Changelog (17-02-2025)

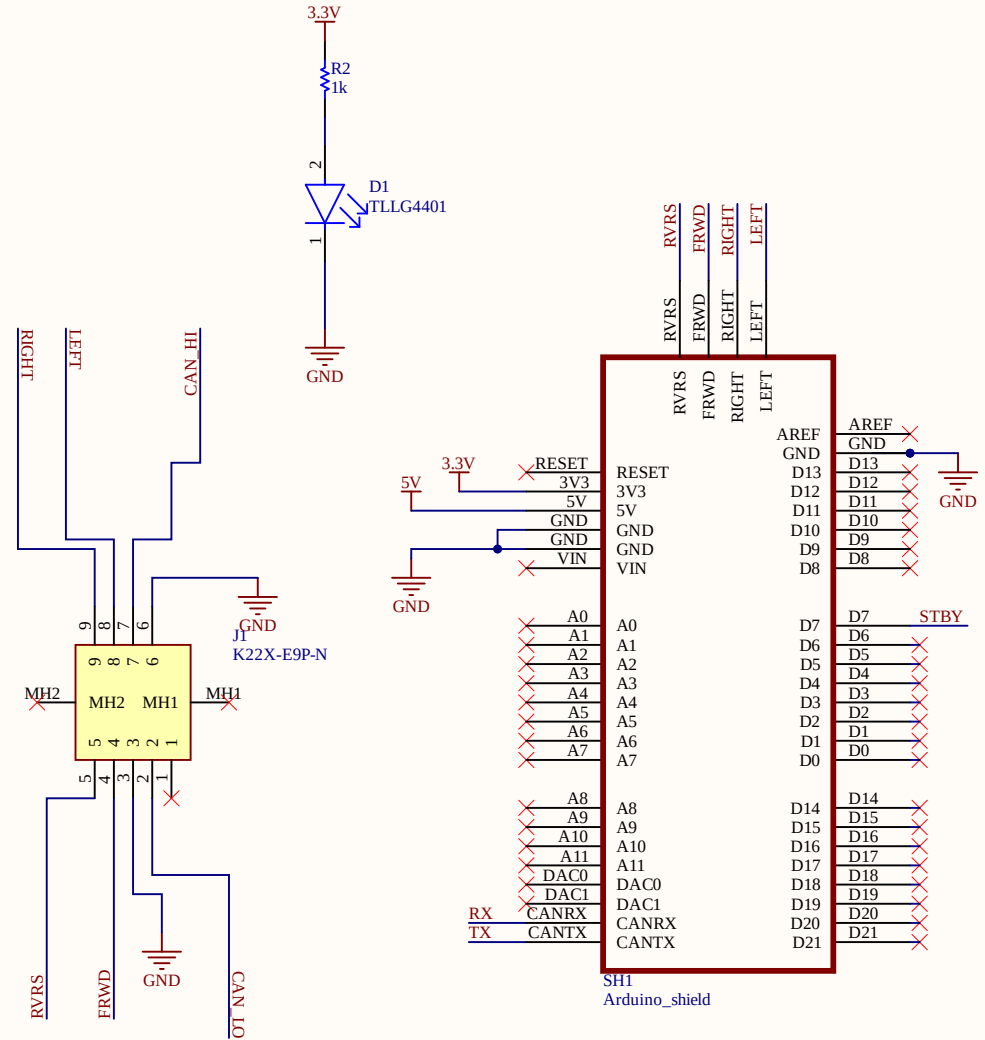
- D1 and R2 as indicator LED (tht for only bottom soldering)
- Attached STBY to D7 with pulldown

3.3V IO to CAN Transceiver
5V to CAN output driver
